**Explosives and related matters: review of tests in
parts I, II and III of the Manual of Tests and
Criteria**

**Manual of Tests and Criteria, update test Series H:
determination of self-accelerating decomposition
temperature**

Transmitted by the Chairman of the Working Group on Explosives

5. The outcome of the discussions and consequent proposed amendments to the **7th revised edition of the manual of tests and criteria** are given in this document. All changes are indicated; inserted text is shown **red** and deleted text in **red, strikethrough**.

Figure 28.4.2.1: Adiabatic storage test

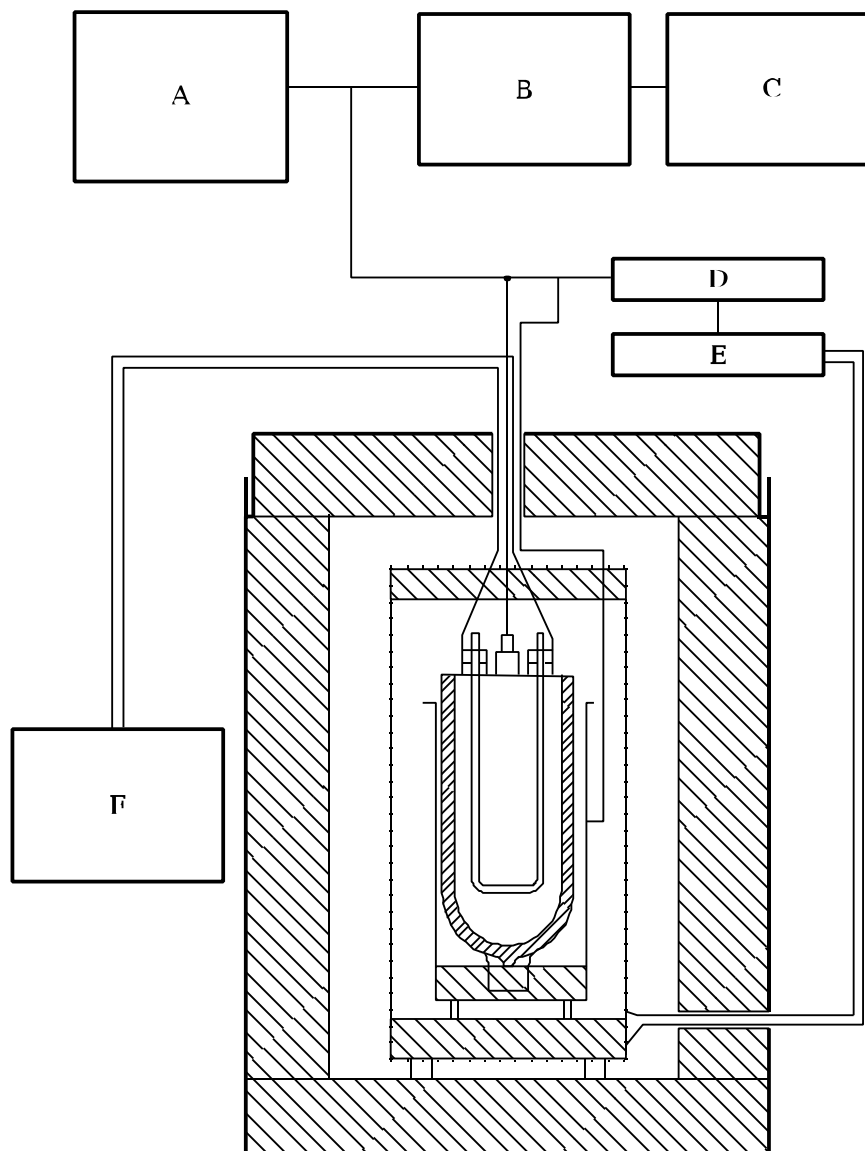
oven at a ~~pre-set~~ preset temperature. A schematic drawing of ~~the~~ an open apparatus for the adiabatic storage test ~~AST~~ is given in Figure 28.4.2.1.

Figure 28.4.2.2: Example of determination of SADT or SAPT

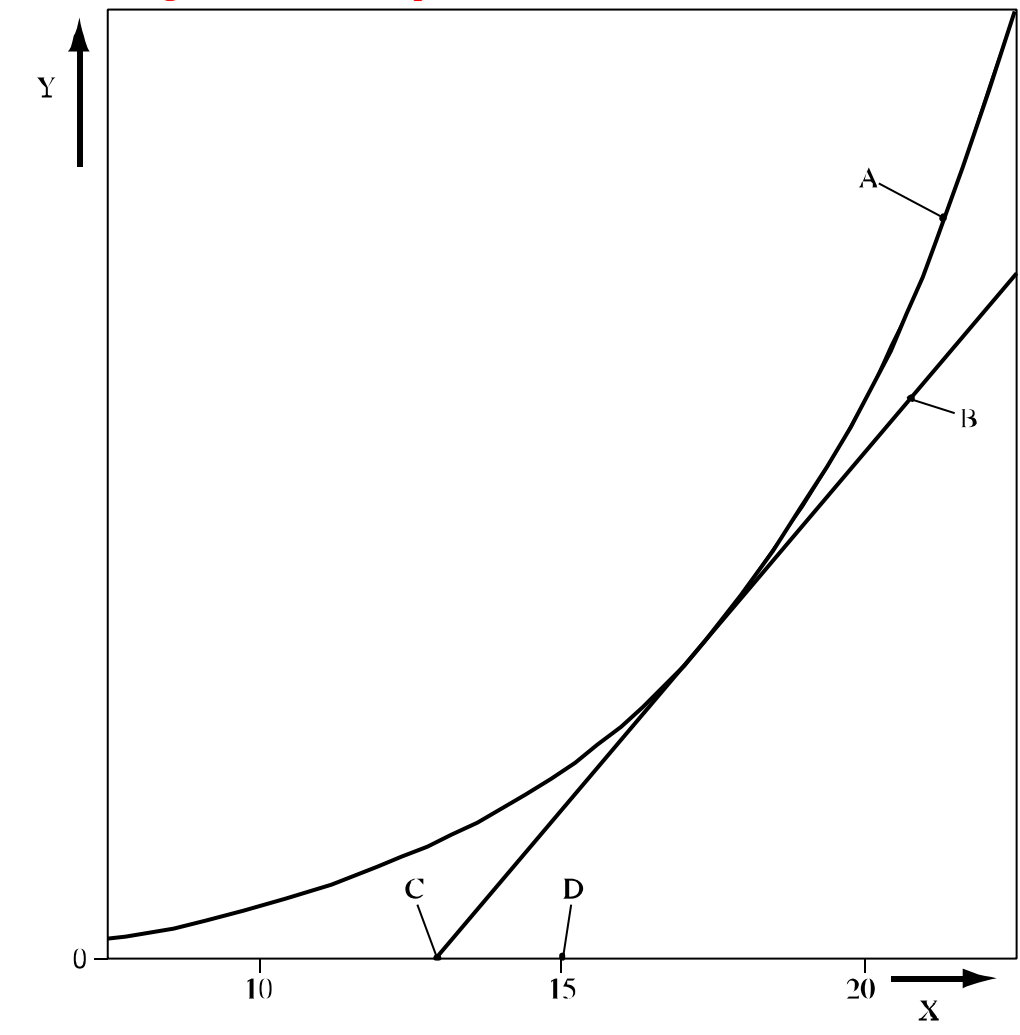
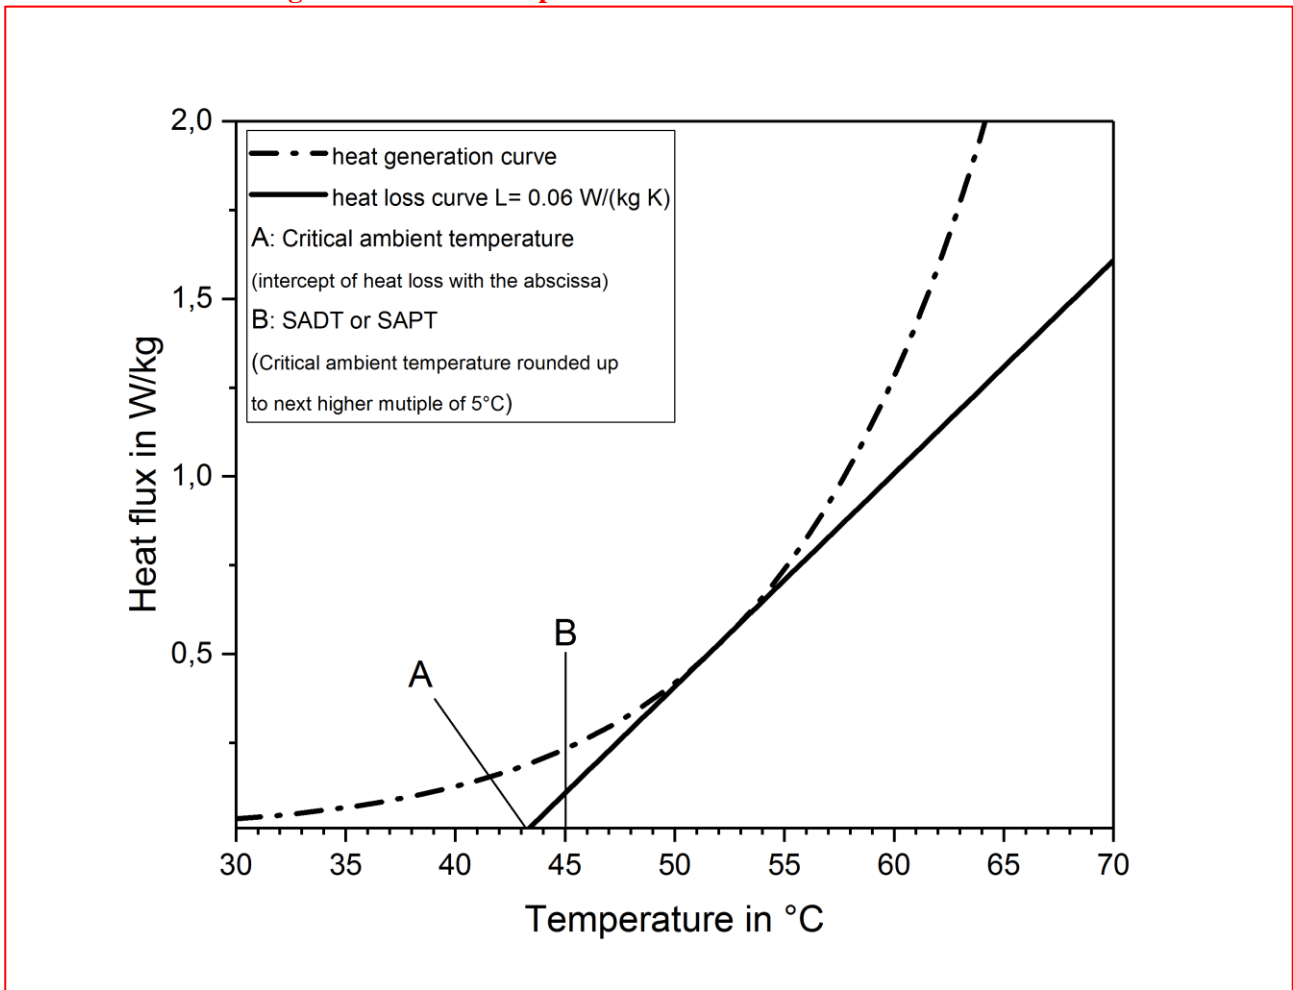
28.4.2.4.6 Plot the calculated rates of heat generation per unit of mass (Q_T) as a function of the temperature in a graph with linear scales and draw the best-fit curve through the plotted points. Determine the heat losses per unit of mass, L (W/kg.°C) of the specific package, IBC or tank (see section 28.3.5). Draw a straight line of gradient L tangential to the heat generation curve. The intersection of the straight line and the abscissa is the critical ambient temperature, i.e. the highest temperature at which the substance as packaged does not show self-accelerating decomposition. The SADT is the critical ambient temperature (°C) rounded to the next higher multiple of 5 °C. An example is given in Figure 28.4.2.2.

Figure 28.4.3.1: Measuring period as a function of maximum heat generation measured

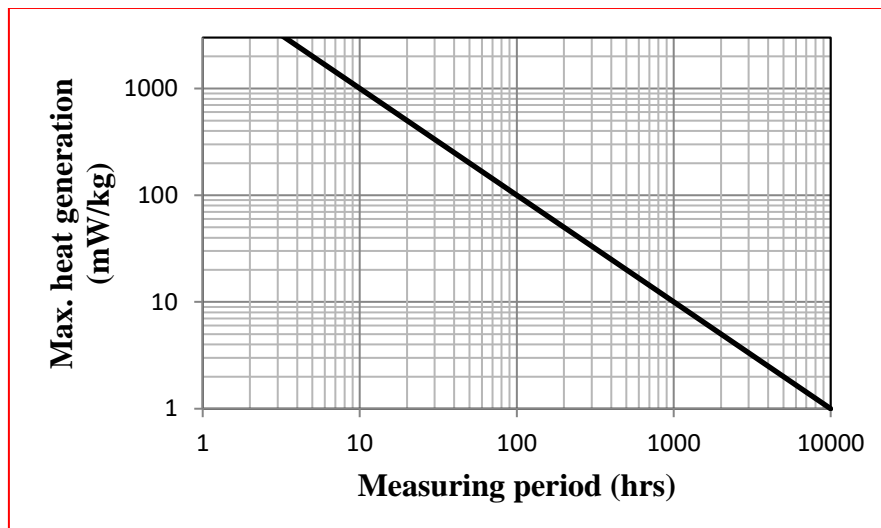
The measuring time as given in Figure 28.4.3.1 can be used as guidance unless it leads to unrealistic measuring times (e.g. greater than 1000 hours). These measuring times are

given to achieve a certain degree of conversion of the substance in order to take auto-catalytic effects into account;^{1,2}

Figure 28.4.3.2: Example of determination of SADT or SAPT

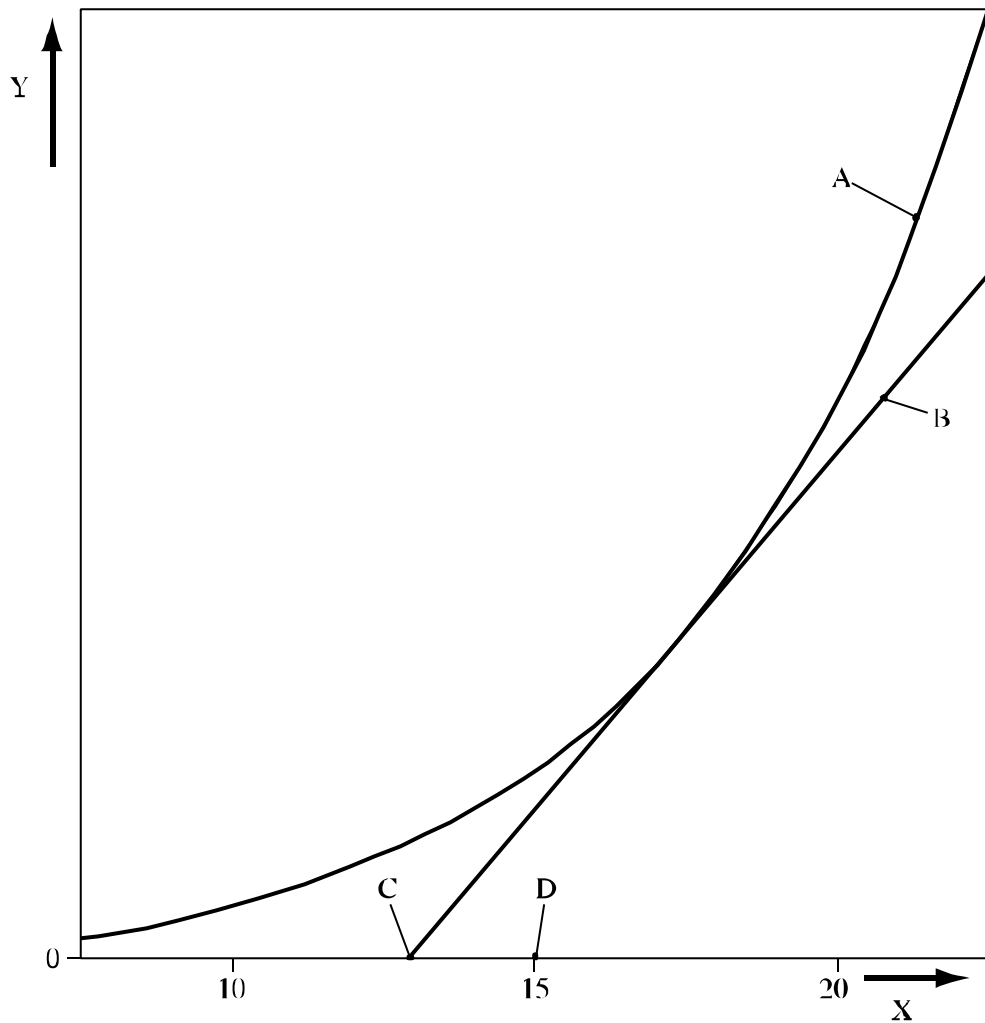
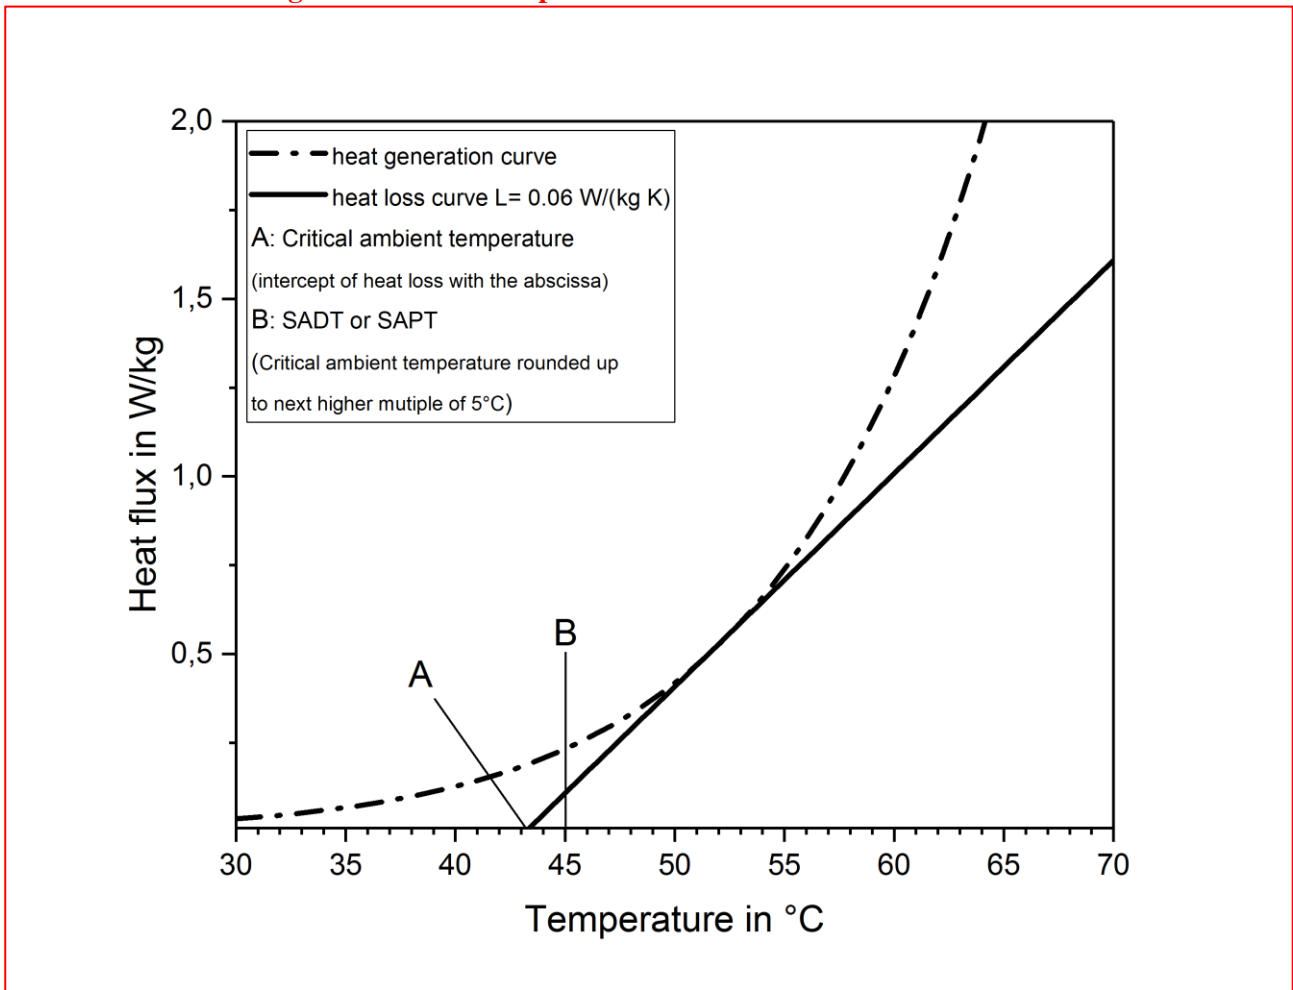
28.4.3.4.13 Plot the calculated maximum rate of heat generation per unit of mass as a function of the test temperature on a graph with linear scales and draw the best-fit curve through the plotted points. Determine the heat losses per unit of mass, L (W/kg.°C) of the specific package, IBC or tank (see 28.3.5). Draw a straight line of gradient L tangential to the heat generation curve. The intersection of the straight line and the abscissa is the critical ambient temperature i.e. the highest temperature at which the substance as packaged does not show self-accelerating decomposition. The SADT or SAPT is the critical ambient temperature (°C) rounded to the next higher multiple of 5 °C. An example is given in Figure 28.4.3.2.

Figure 28.4.4.1: Dewar vessel with closure for testing liquids and wetted solids

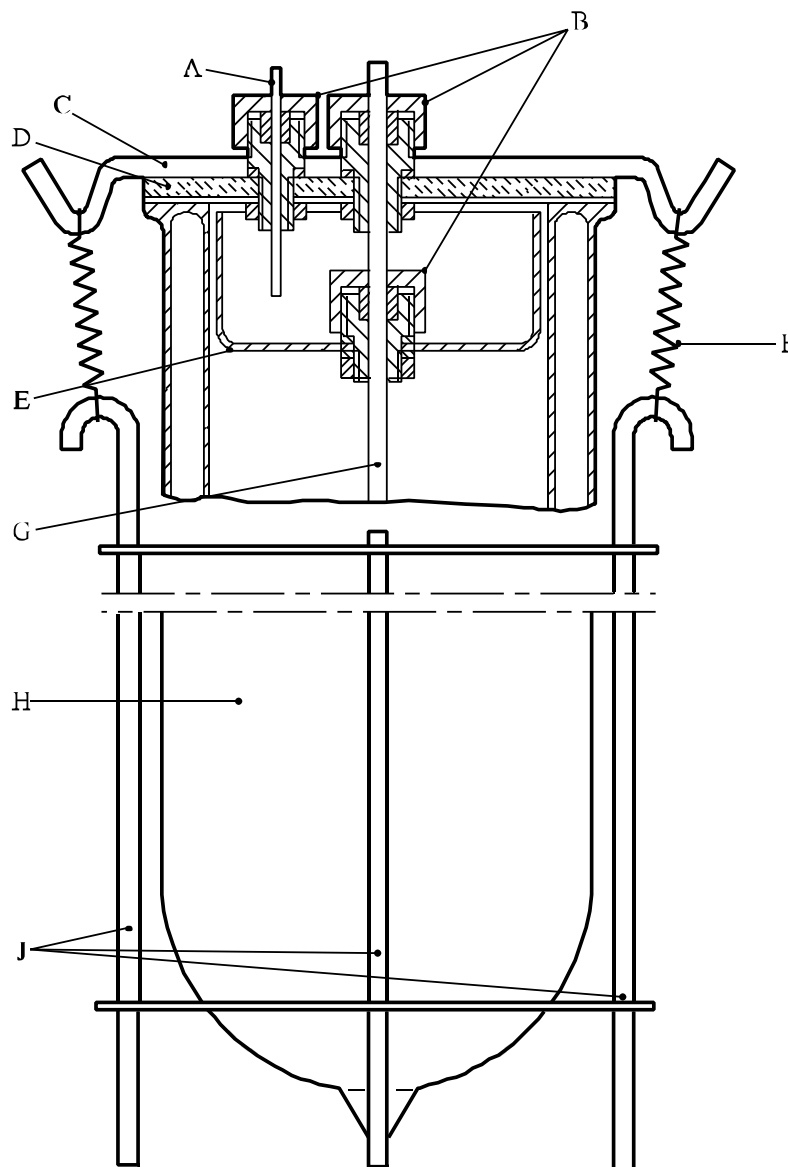
28.4.4.2.6 Dewar vessels, with their closure system, are used with heat loss characteristics which are representative of the maximum ~~size of~~ package size under investigation (see also table 28.4) ~~offered for transport~~. The closure of the Dewar vessel should be made of inert material. Particularly for solids, cork or rubber bungs may be used. An example of a closure system for use with liquids with low or medium volatility

and wetted solids is illustrated in Figure 28.4.4.1. Samples which are highly volatile at the test temperature should be tested in a pressure-tight ~~metal~~ vessel **that is made of a material compatible with the sample and** fitted with a pressure relief valve. The pressure vessel is placed in the Dewar vessel and the effect of the heat capacity of the metal vessel taken into account by calculation.
